Serial No.: 10/796,246  
Docket No.: MIO 0069 VA/40509.245

**Amendments to the Drawings**

Please replace sheet 3 of 4 containing Figs. 5 and 6 with the Replacement Sheet 3 of 4 enclosed herein.

FIG. 6

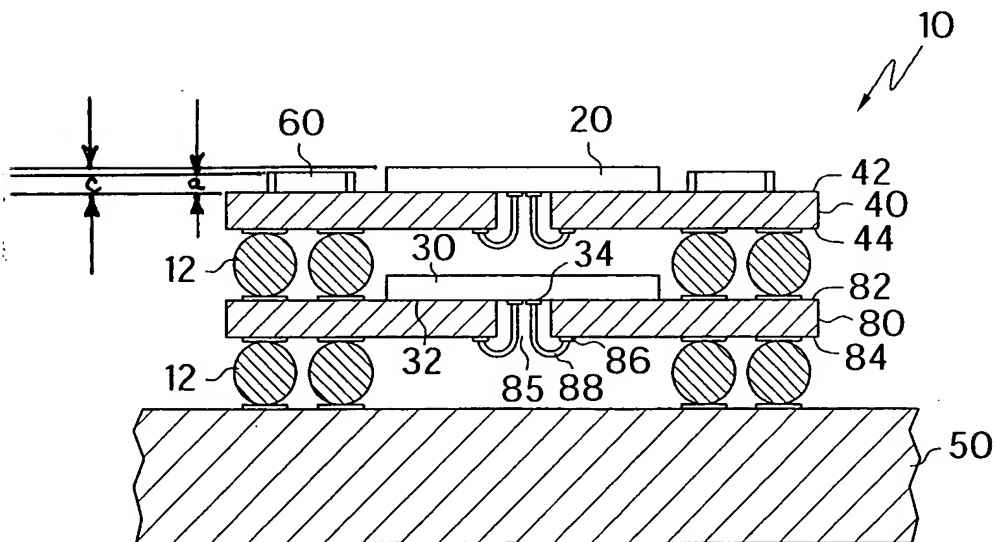
Applicants have amended the drawings to reflect what is described on page 14, lines 11-16 of the specification, and described in the original claims, for example original claims 2 and 16. Thus, no new matter has been added. Accordingly, an amended paragraph has been enclosed herein.

Applicants have amended the Cross Reference To Related Applications section on page 1 to list the related applications and update the applications status. Also, Applicants have amended page 14, lines 11-16 of the specification to describe what was shown in Fig. 6 and describe in the original claims, for example original claims 2 and 16. Thus, no new matter has been added. Accordingly, an amended paragraph has been enclosed herein.
